AMENDMENT OF SOLICITATION/MODIFICATION OF CONTRACT

1. Replace the Bidding Schedule, pages 00010-3 and 00010-4, with the accompanying new Bidding Schedule, bearing the notation "ACCOMPANYING AMENDMENT NO. 0004 TO SOLICITATION NO. DACA63-03-B-0004."

E1-63
SKETCH

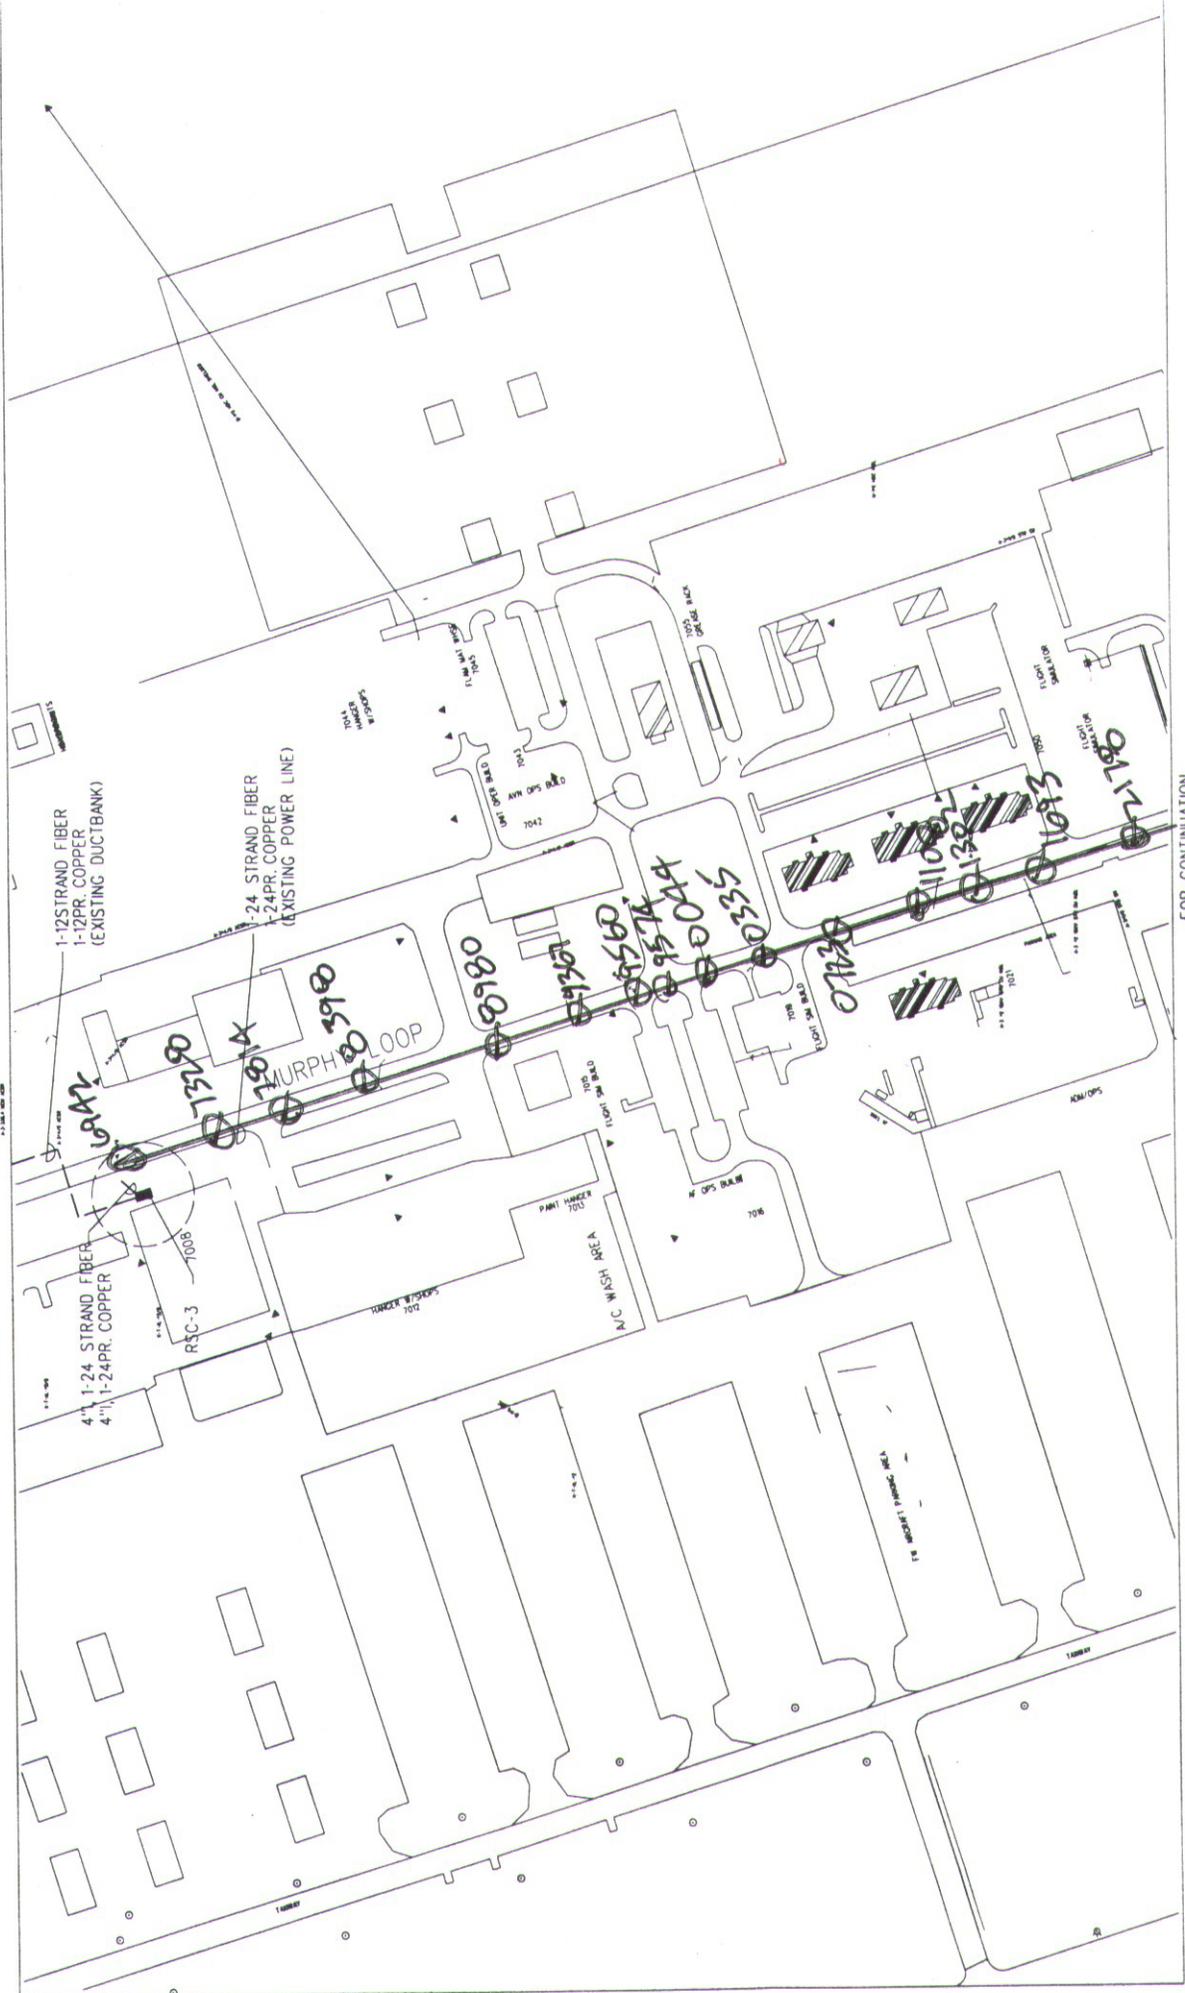
On Sheet E1-63, The Existing Power Line with 1-24 strand fiber and 1-24 pr. Copper extends to sheet E1-64. **Please see attached sketch E1-64.**
